An Bord Pleanála, 64 Marlborough St. Rotunda, Dublin 1.

# RE : Dart + West+ Project . Reference 314232 . Interested Party not notified and excluded from process.

My Name is Cathleen Herbert and I wish lodge an objection and make observations in relation to the planning application submitted by Dart + West for planning permission for new Railway lines and Depot located between Maynooth & Kilcock. The project in its current form (your application reference 314232) is unacceptable and the application is invalid in so far as it has failed to adhere to the most basic planning regulation and furthermore I want to formally make a request for an Oral hearing.

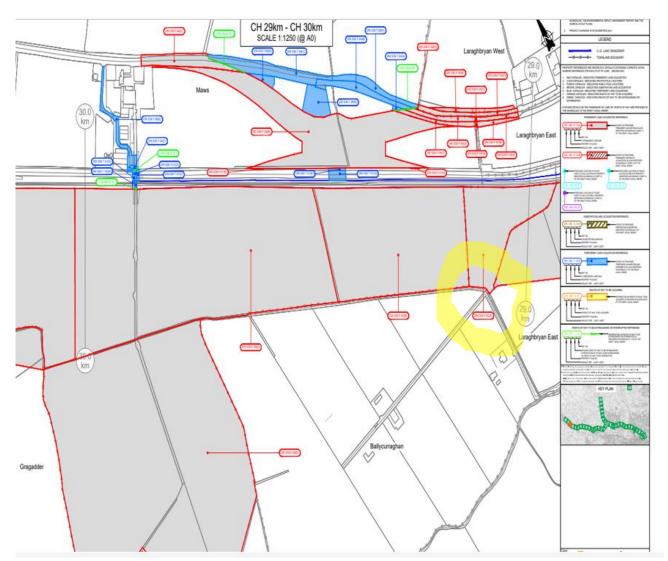
Figure 2 show a picture of the proposed work at the depot with alteration to private laneway at Ballycurraghan circled in yellow. Clearly this work should have been included as part of the Railway order as a private right of way and a private road is being altered. Neither Irish rail or their consultants notified or engage with me in relation to this work

Depot - General Layout.

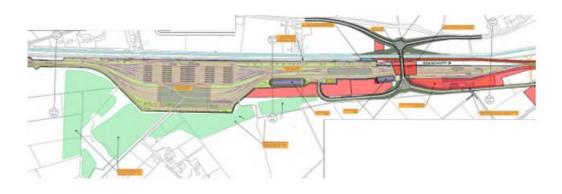
The drawing for depot are not properly complete and doesn't include proper levels . It is not possible to compare the levels of the new works as compared with the existing levels of the surround countryside

Picture of Junction for Ballycurraghan Road and Jacksons Bridge

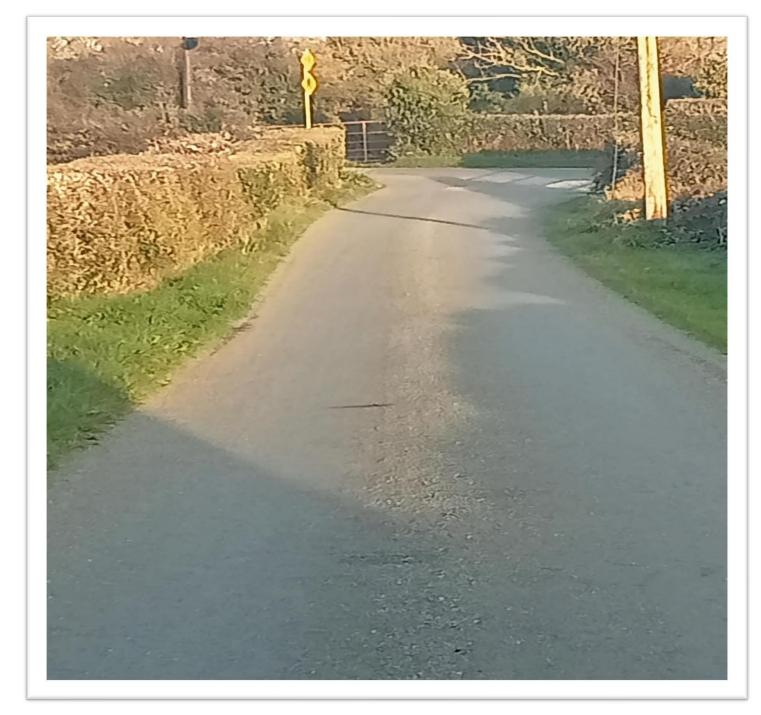
Levels at Jacksons Bridge and Train Levels Showing train line actual train level 1.4 m above flood plain average or just below level of hedge.

#### Compensatory ponds for flood at Jacksons Bridge.

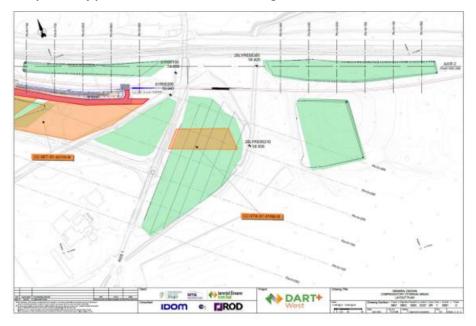
On further reading, it would appear that the requirement for this new entrance to Ballycurraghan is because the existing lane way will be impassable during flooding and this additional entrance to the Ballycurraghan laneway is required as it will be the only access available for the residents of Ballycurraghan to access the L 5041 during flooding. It is my understanding that the level of the new link road will be substantially higher than the lane way to Ballycurraghan possibly as much as two meters higher or level 61.00 with the existing laneway at 59.00. I have carefully read all the planning file in relation to this application, and I cannot find finished level of road or railway lines. There is one level on a drawing in relation to the depot which indicated a level of 64.00 which is two meters above the level of my home in Ballycurraghan. The planning applications does not clearly set out finished levels, However the flood relief proposals indicate the new link road higher than the flooding to the floodplain in Larabryan West which is the only information I have to go on.

You will note from the Drawing above which is the Post Development climate change scenario at OGB23 which clearly show the proposed new link road L5041 and proposed new rail above the flood plain. Gheel Autism buildings and its residents are flooded and there is no provision to defend or protect this area in this planning application. The existing road L5041 is flooded at Threadstown and a considerable section of the M4 is impassible in the region of 5 km. You will also note that there is no flooding to the north of Jackson Bridge as the 10-acre flood plain on Maynooth college lands was raised by 3.0 m during construction of M4 without proper permission being sought. In places where this land meets the tow path for the canal and particularly at Jacksons bridge its clearly visible the extent of the land fill with earth piles up against existing trees by as much a 2.5 m which is causing them to struggle and die.

Appendix A20.4 Geophysical Survey Report

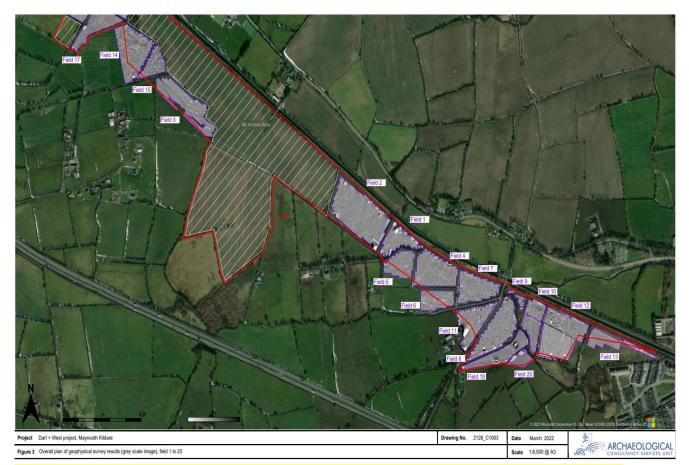
It's important to note here that the proposed Entrance to Ballycurraghan from link road L 5041 has not identified the cut-stone bridge and large tracts of the proposed depot site have not been investigated at all.

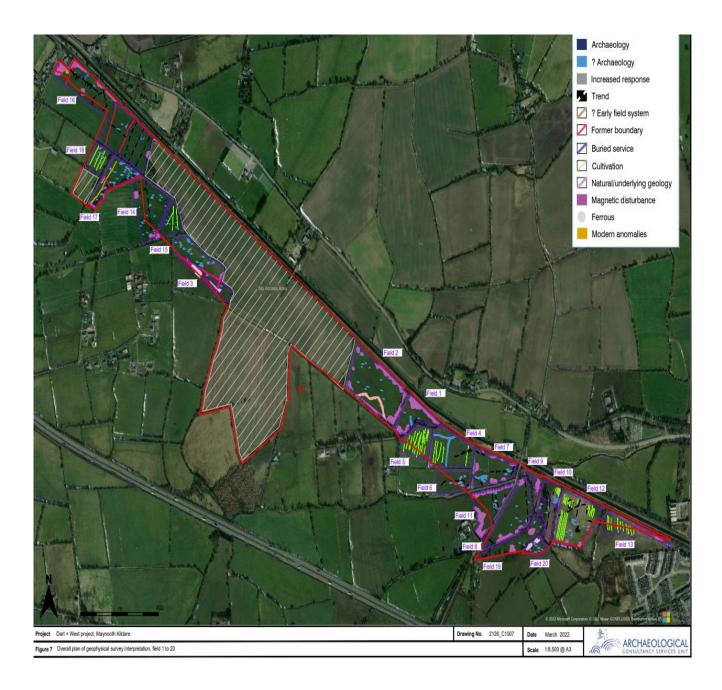
This plan shows the significant area around the depot which has not been investigated at all quoting reason for saying has no access.

Here we can clearly see almost 100 acres of the proposed site has not been inspected or investigated

Figure 6-1 Proposed Compensatory Storage Area - Jacksons Bridge

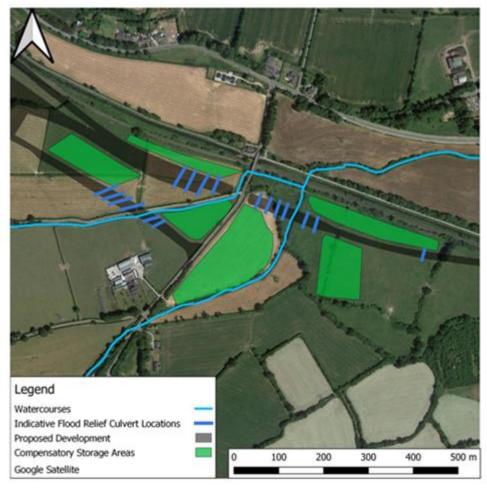
The flood management guidelines state that one should not build inside these flood areas because it will displace the flood water and change the shape of the flood. Now Irish Rail are proposing compensatory storage, which means the flood volume they are displacing can be catered for within specifically engineered locations as shown on Irish Rail map extract from their flood risk assessment below represented by green areas. However, upon review, it is clear that some of the proposed areas for compensation lie within existing flood zones and this is not good practice.

In this regard, the proposed works could impact on the existing "shape/extents" of the current modelled flood, causing locations to perhaps flood that never flooded before and indeed, as in the case of the Gheel service which is currently in a less frequent 1 in 1000-year flood zone, pushing flood waters further west and rendering the Gheel service within the more frequent flood zone A, 1 in 100-year event. This, in accordance with the Flood Management Guidelines and planning policy is not acceptable.

Picture of Junction for Ballycurraghan Road and Jacksons Bridge

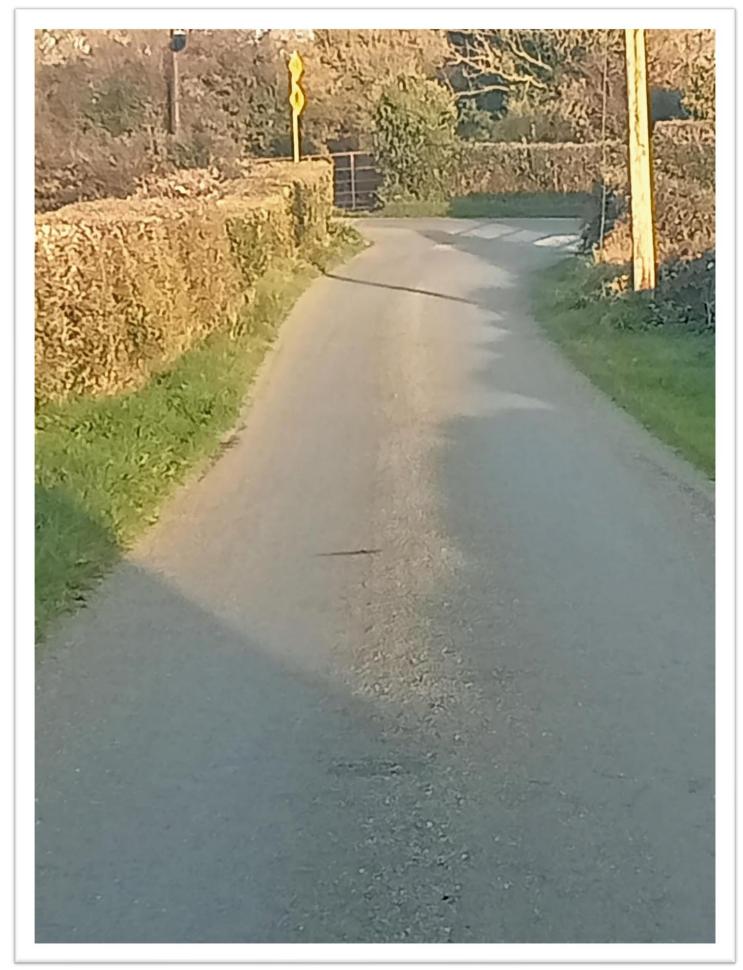
<u>Levels at Jacksons Bridge and Train Levels Showing train line actual train level 1.4 m</u> above flood plain average.

Blue line in picture above represents 60.36 which 1.40 above Ballycurraghan Lane level. Extent of flooding at Jacksons bridge prepared by author
